**Re: Comment Letter 2
1015 East Street – “Gilmore”
Comprehensive Permit (40B) Peer Review
Walpole, Massachusetts**

The following is an update to our September 6, 2023 Comment Letter adjusting prior comments in consideration of supplemental material provided by the applicant including their responses to comments, revised site plans, supporting documentation, and clarifying testimony presented at public hearing.

TT SKETCH !
NOV 1, 2023

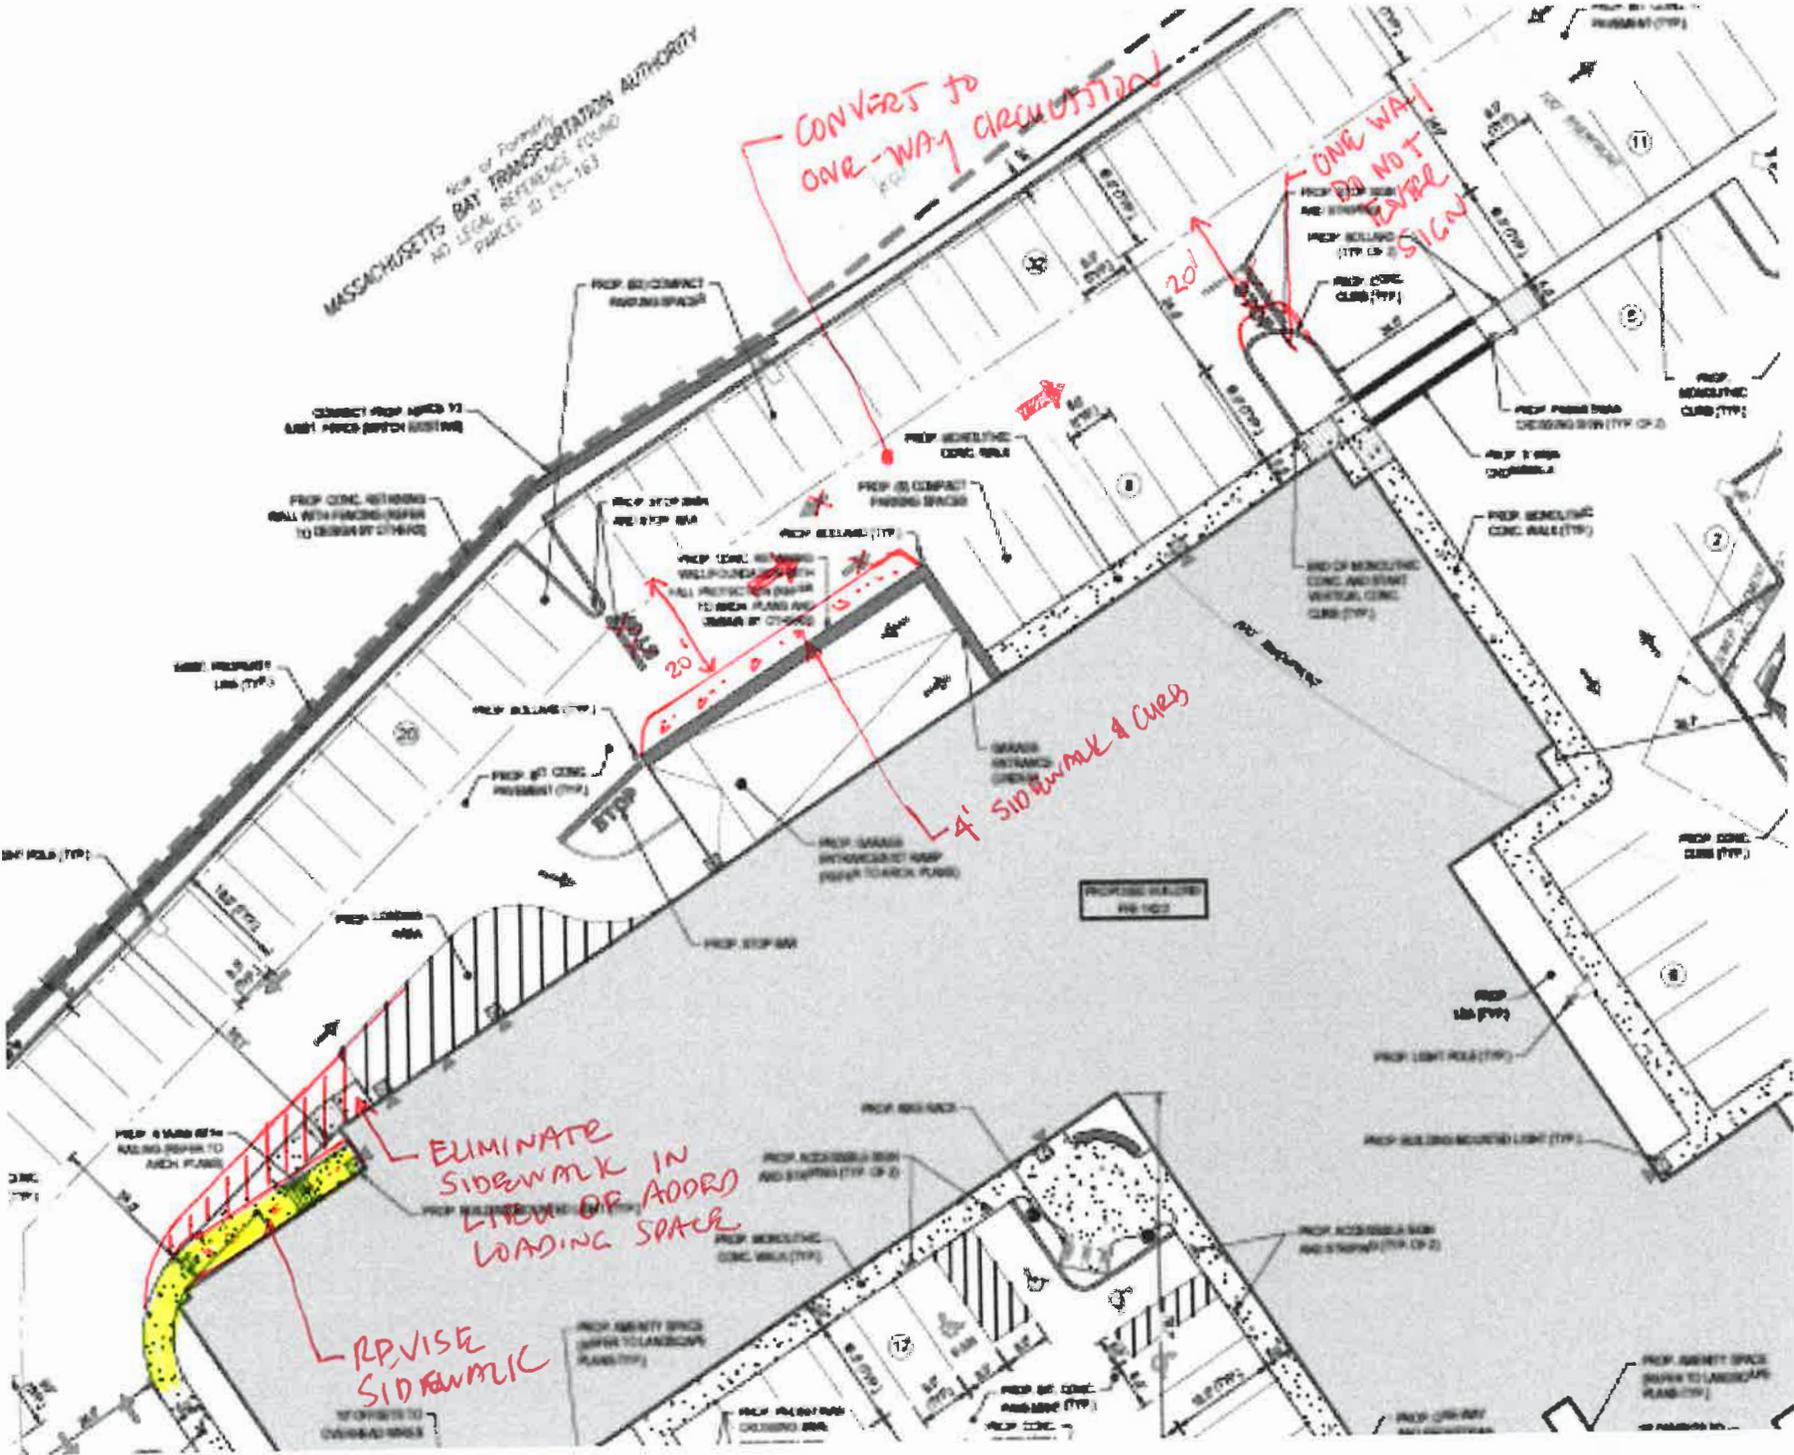
11-01-23 Update: Response indicates facility loading will be accommodated using a small area set aside at the front entry for short term deliveries with larger longer-term deliveries staged within the limited available space at the back of the building outside the garage ramp. These accommodations are modest but not atypical for urban applications and the 24’ drive/parking aisles could provide short-term supplemental space with proper oversight and controls to maintain emergency access and safe circulation. We recommend the applicant consider modifying the sidewalk layout outside the southwest corner of the building to maximize space available for loading as shown on the attached TT Sketch 1.

11-01-23 Update: Response indicates a continuous sidewalk is not possible given site limitations nor required given the limited number of unserved parking areas, the location of the garage entrance, and low volume expected at the rear of the building. In our opinion this is a reasonable approach but suggest a modification to the circulation pattern at the rear of the facility to improve safety for exiting garage traffic as well as pedestrians. See attached TT Sketch 1.

11-01-23 Update: Response proposes adding stop bars to address the visibility/sight line concern which in our opinion are not likely to help and are potentially counter-productive. Instead, we recommend that applicant consider limiting the rear drive aisle between the garage entrance and the eastern portion of the site to one-way in an easterly direction. This change eliminates vehicles approaching the garage exit from the east while providing a less complicated traffic pattern and a bit more available space for pedestrians. See attached TT Sketch 1.

CONVERT TO
ONE-WAY circulation

ONE WAY
DO NOT
EXTRA
SIGN

ELIMINATE
SIDEWALK IN
AREA OF ADD'D
LOADING SPACE

REVISE
SIDEWALK
